October 4, 2024

PERFORMANCE BULLETIN 142 540 Threaded ½" Ejectors to Spears Tee

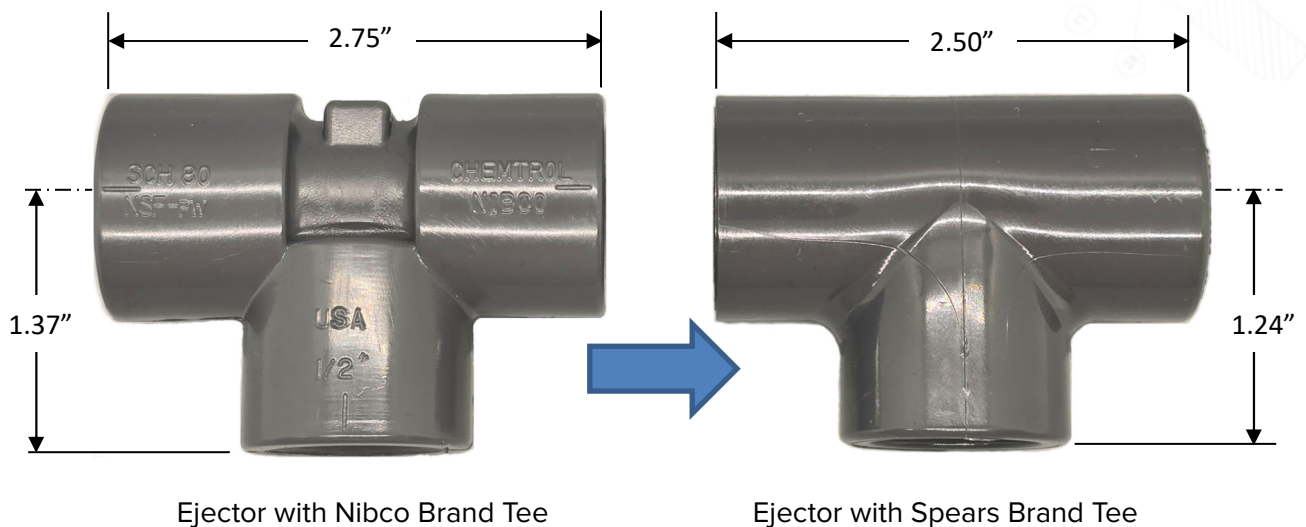
The tee used to make 540 series ½" threaded Ejectors will be changing brands from Chemtrol Nibco to Spears. This change is being made because the Spears tees are more consistently sized making them easier to machine.

The new tees are slightly smaller as shown below. The dimensions shown on the spec sheet have been updated as a result of this change.
